THE COUNTY OF GALVESTON

PROJECT NAME: JACKSON AVENUE DRAINAGE IMPROVEMENTS

SOLICITATION NO: ITB #B211044

RE: ADDENDUM #1

JACKSON AVENUE DRAINAGE IMPROVEMENTS
JACKSON AVENUE PLAN AND PROFILE
STA. 5+00 TO STA. 10+00

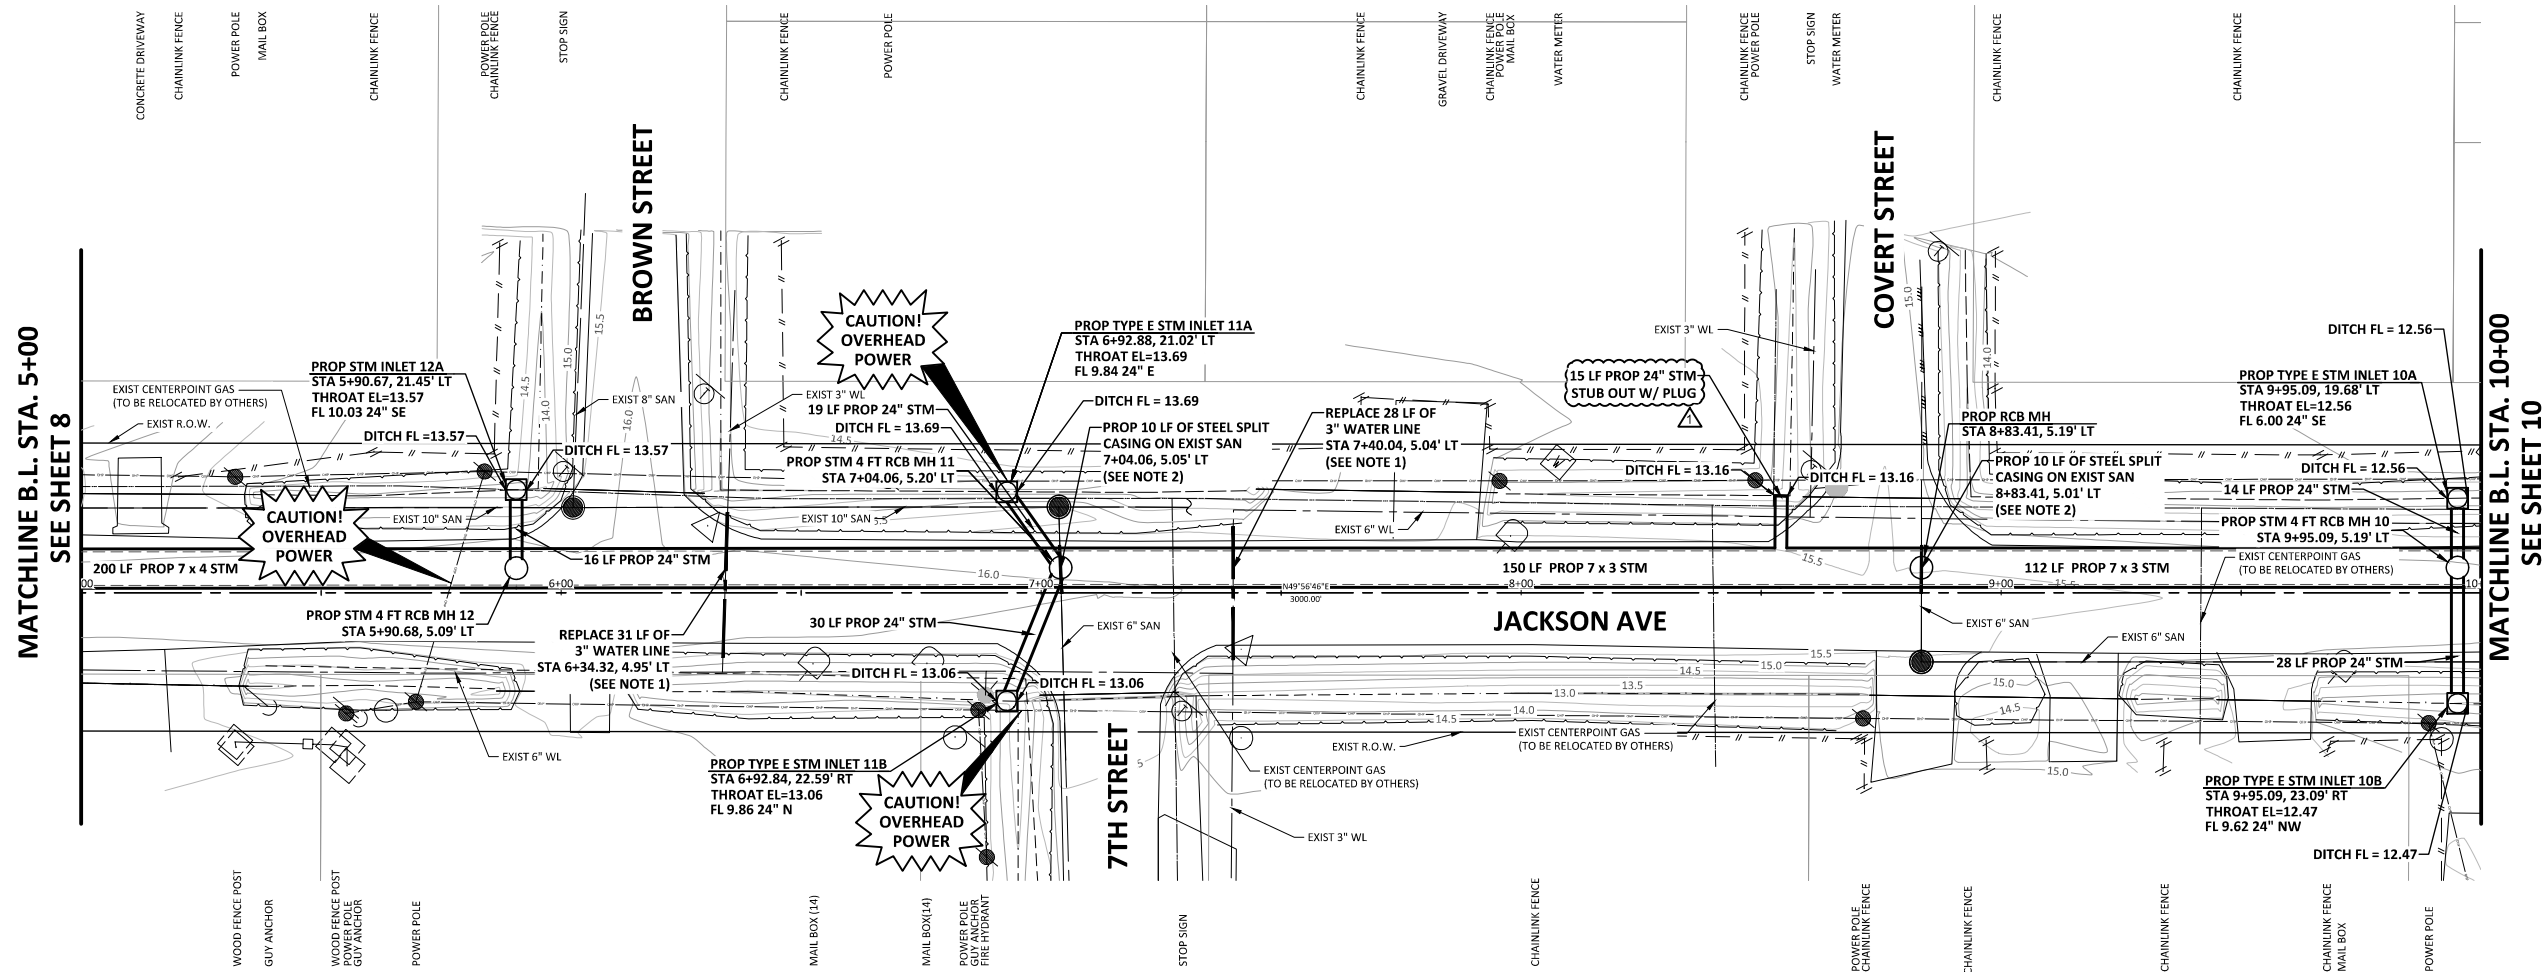
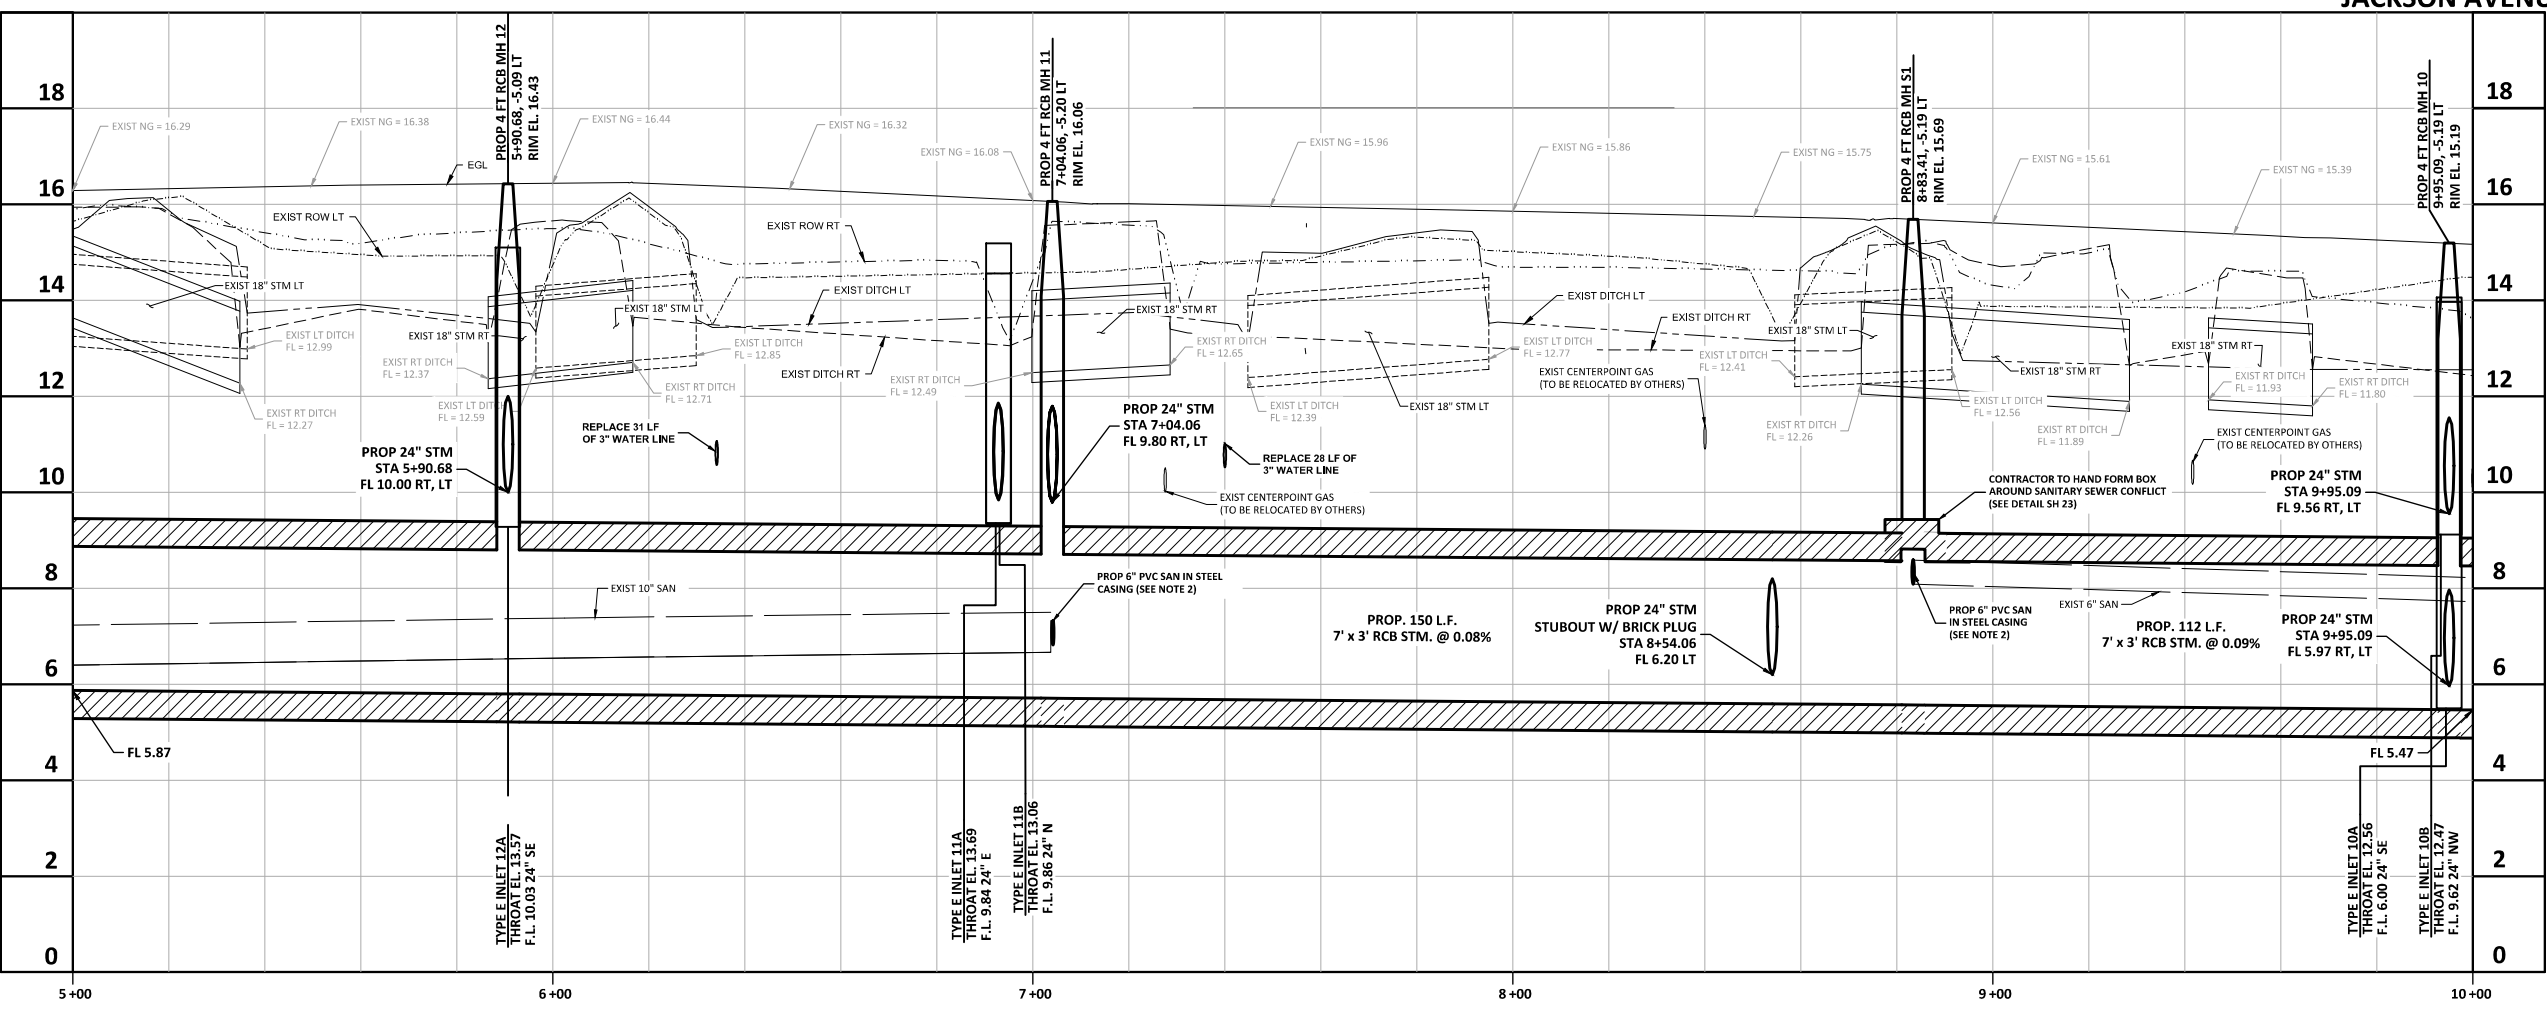
Item No. 7 ***Question: There is no pay item for the 24” brick plugs called for on sheet 9 and 10.***

Answer: Bid item No. 14 – “8” Grout Plug for 24” RCP” added. Remove and replace entire plan sheets 9 and 10 with plan sheets marked Addendum No. 1.
